Base Load Power Hub (BLPH)

60% 3D Model Review Report

Document Number: 123A90-DDL-PP-RE-70009

BLPH - 60% 3D MODEL REVIEW
ACTION ITEM REGISTER

MR60-TAG23

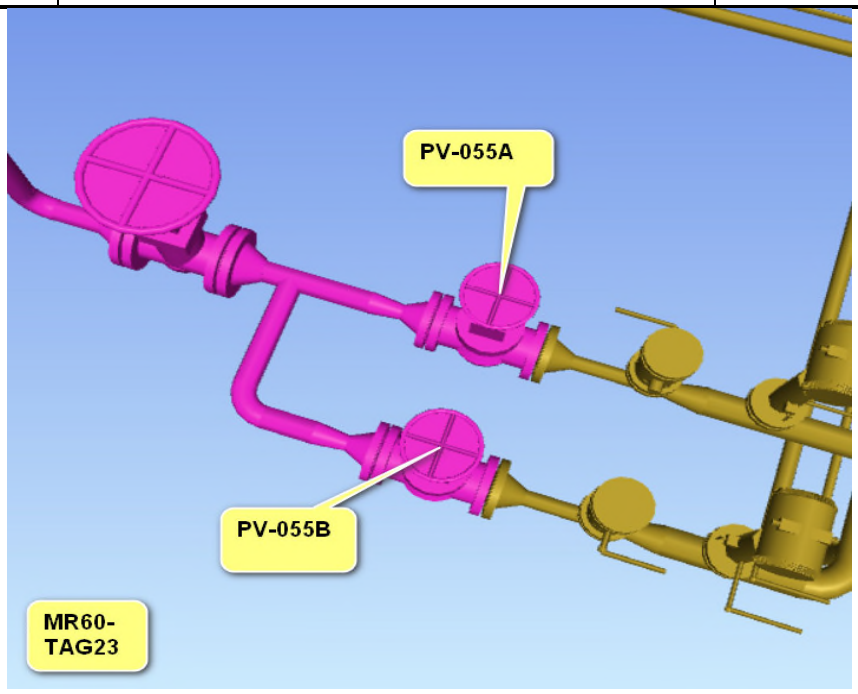
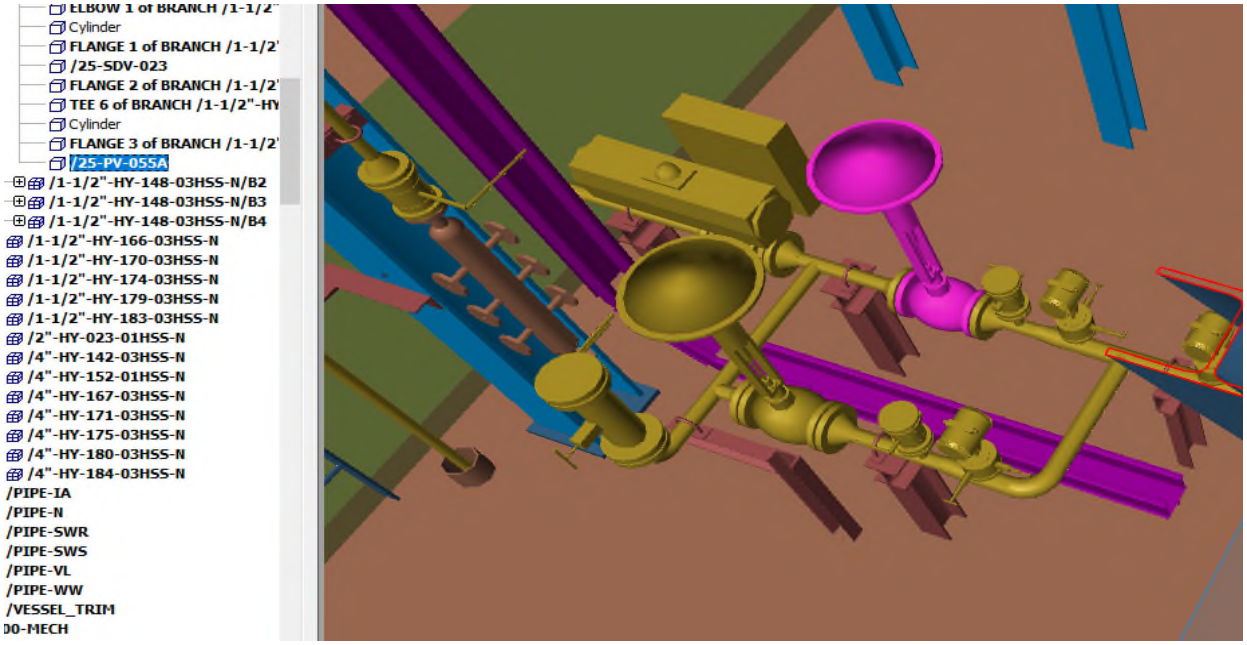
To update the model according to the P&ID (PV-055A is installed on the main pipe)

The valves have been updated according to the P&ID.

MR60-TAG24

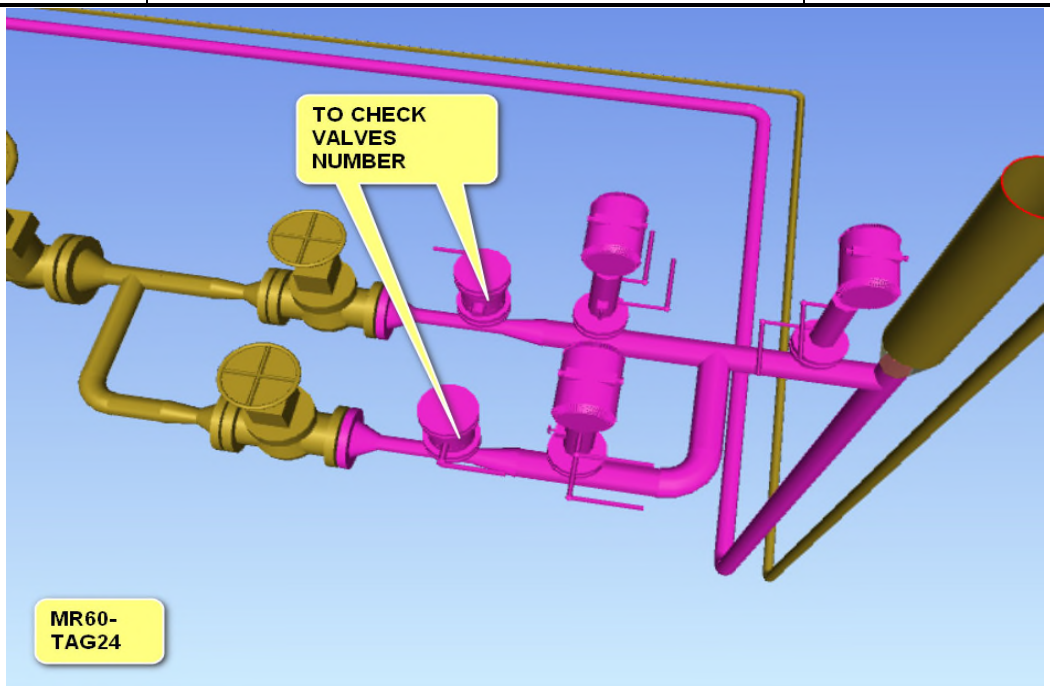
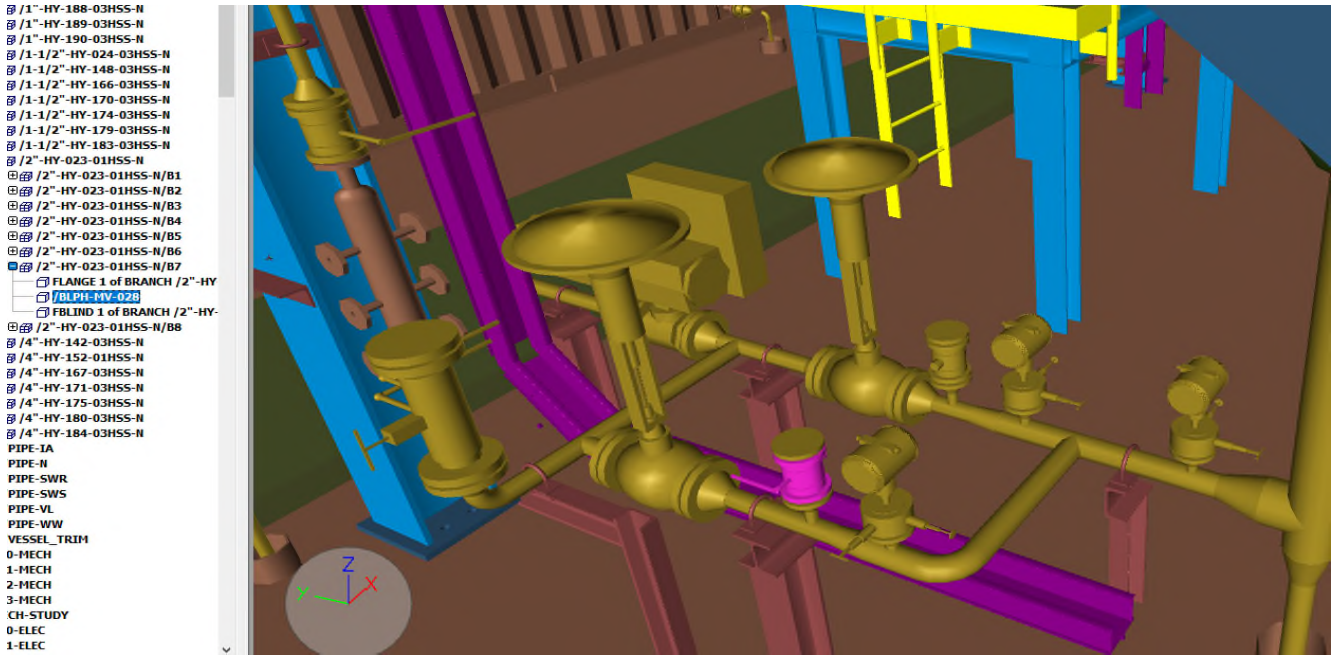
To check valves numbers

The valve numbers have been checked and corrected

MR60-TAG26

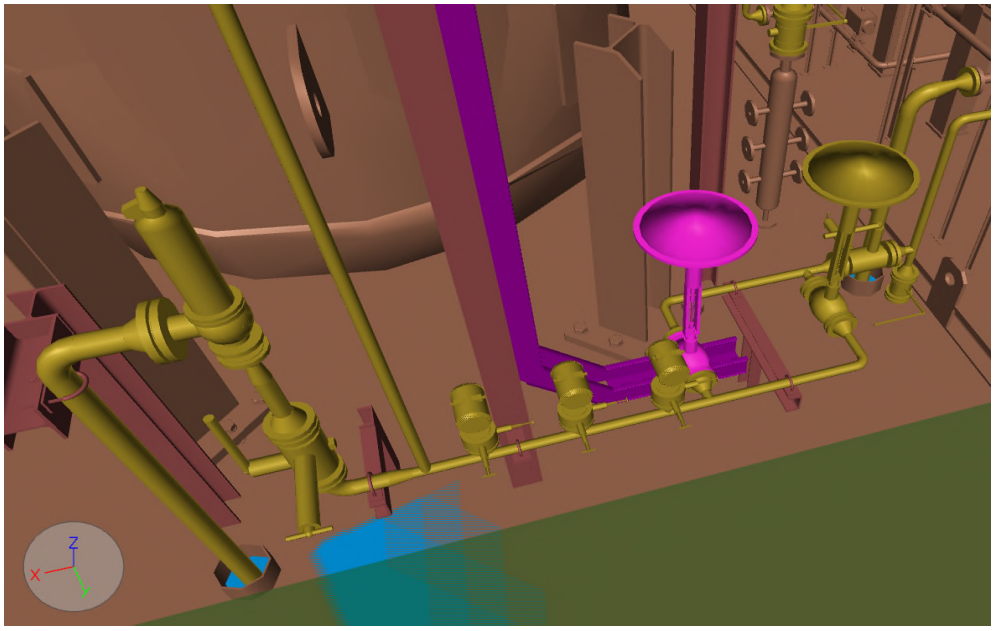
To update the arrangement and replace the manual valves with instrument valves

The routing has been updated and the manual valves have been replaced with automatic valves

MR60-TAG27

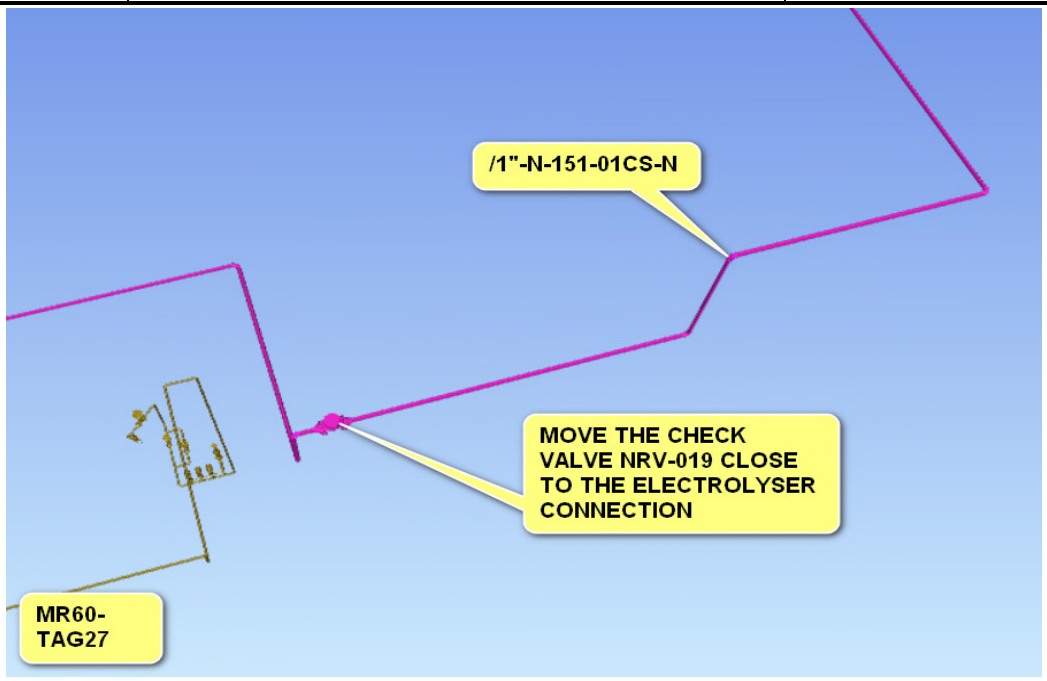
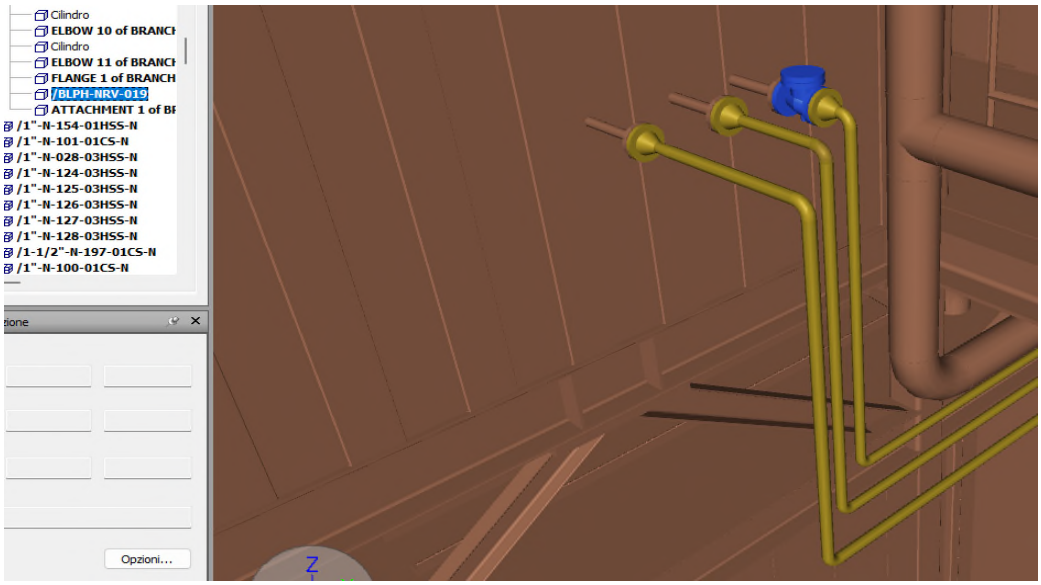
Move the check valve NRV-019 close to the electrolyser connection

The check valve NRV-019 has been moved closer to the new Electrolyser connection point

MR60-TAG28

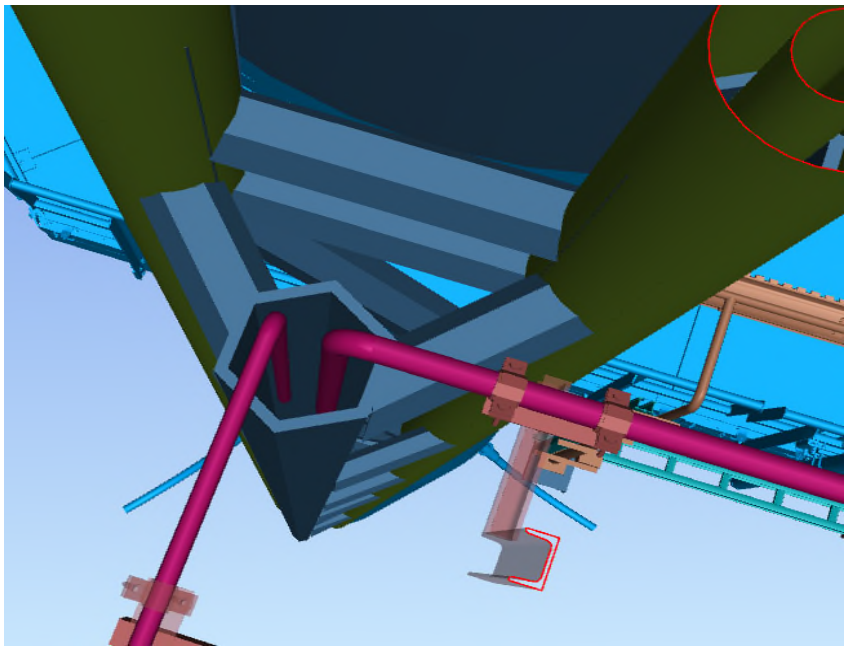
To extend the end of pipes -5m below the L.A.T.

The end of pipe has been extended 1m into the brine caisson

MR60-TAG29

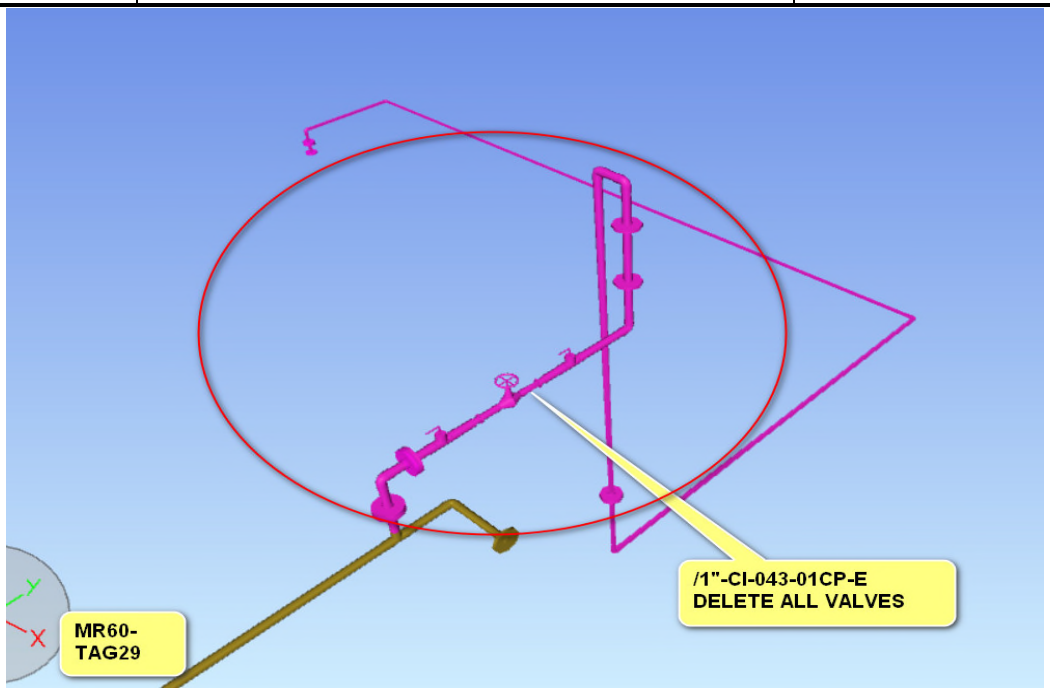
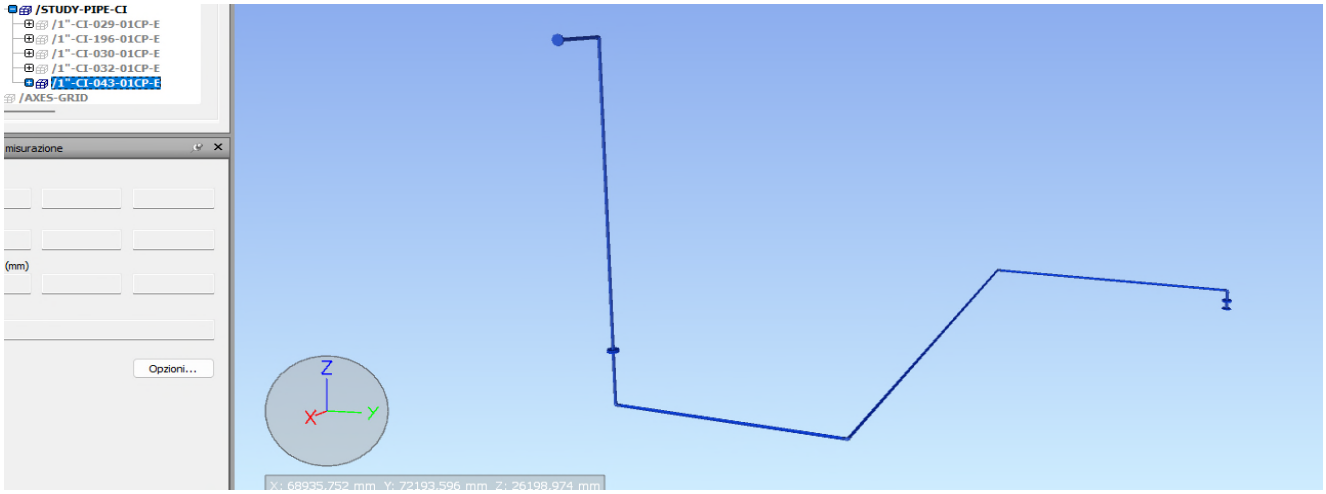
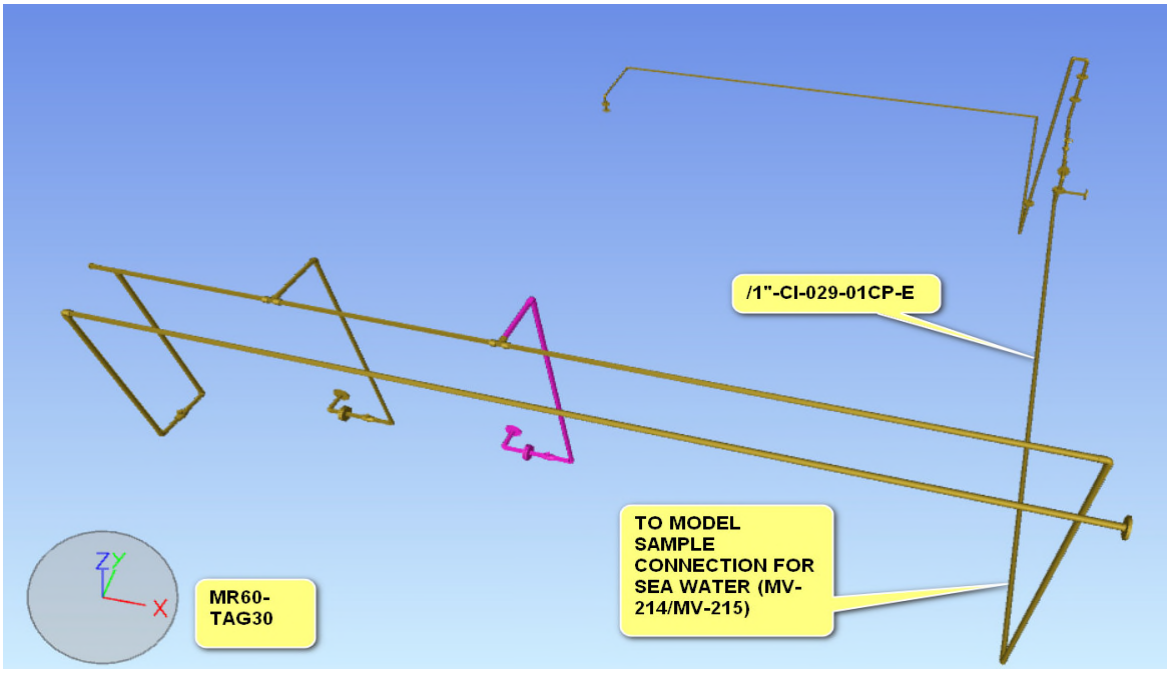
Line 1"-CI-043-01CP-E Delete all valves

The valves have been deleted and the Line 1"-CI-043-01CP-E routing has been updated

MR60-TAG30

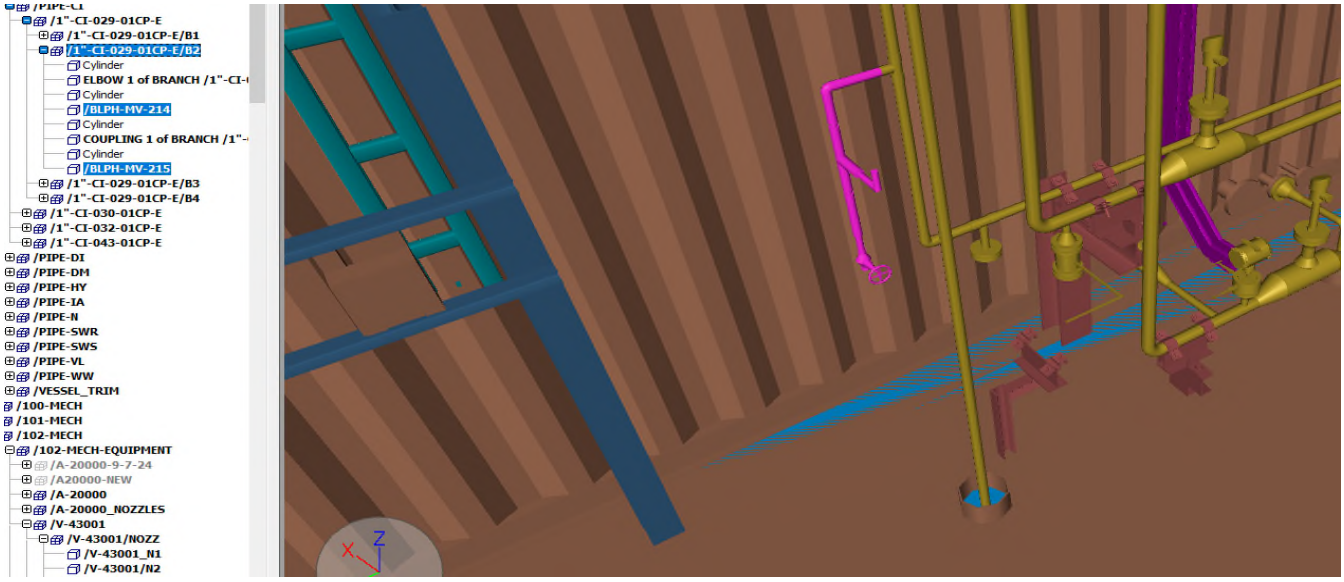
To model sample connection for sea water (MV-214/MV-215)

The sample connection has been modelled

MR60-TAG31

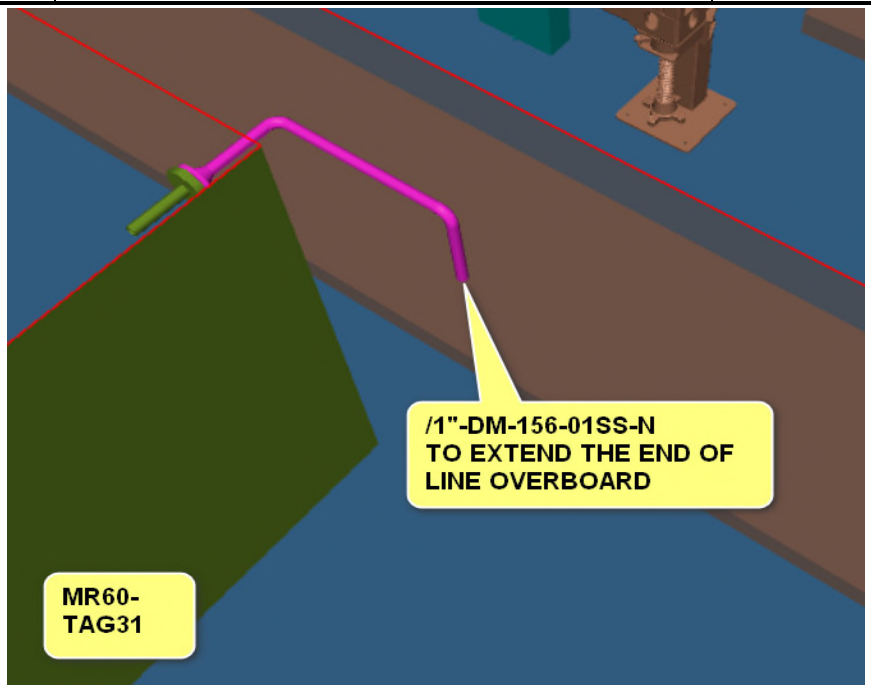
CPY to confirm if this is considered confined space.

The line has been deleted

MR60-TAG03

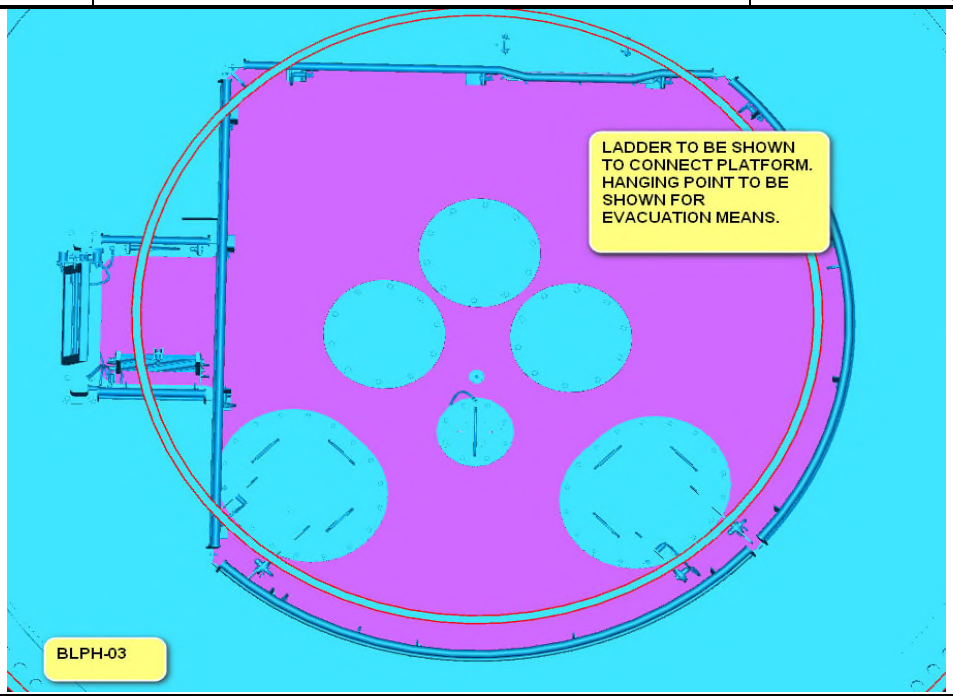
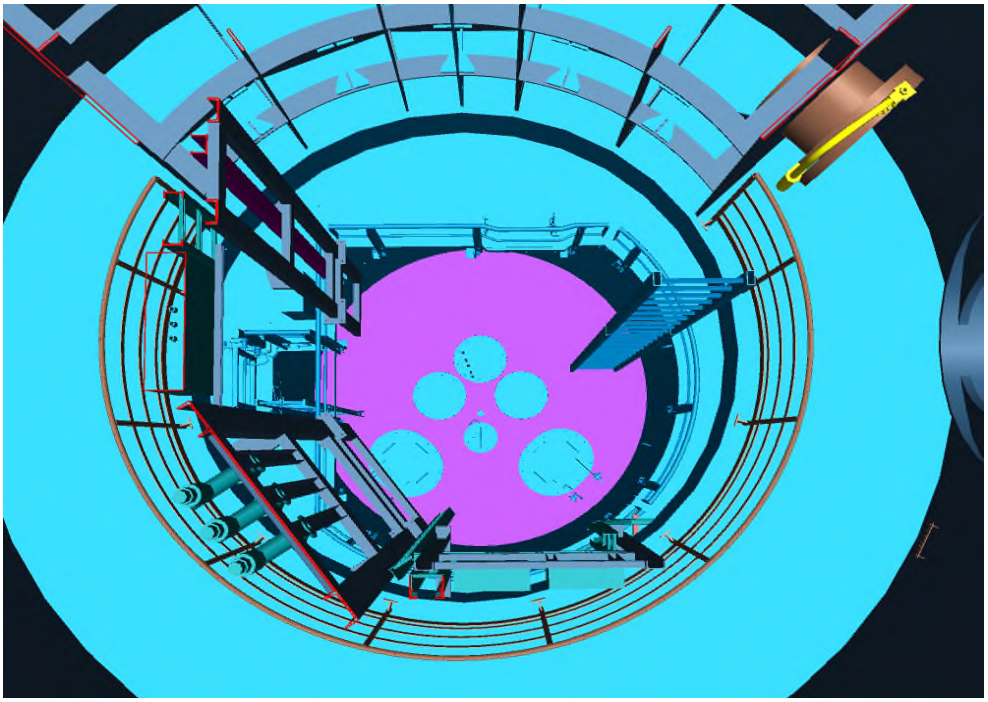
Ladder to be shown to connect platform. Hanging point to be shown for evacuations means.

Ladder provided

MR30-TAG07

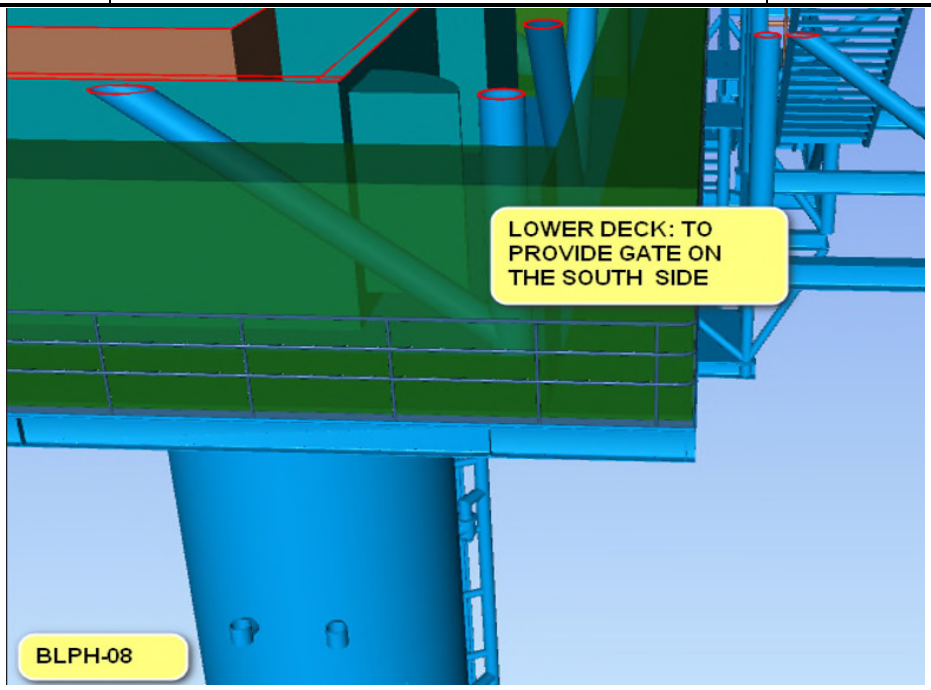
Anchor point for existing winch to be shown.

Action postponed to 90%MR
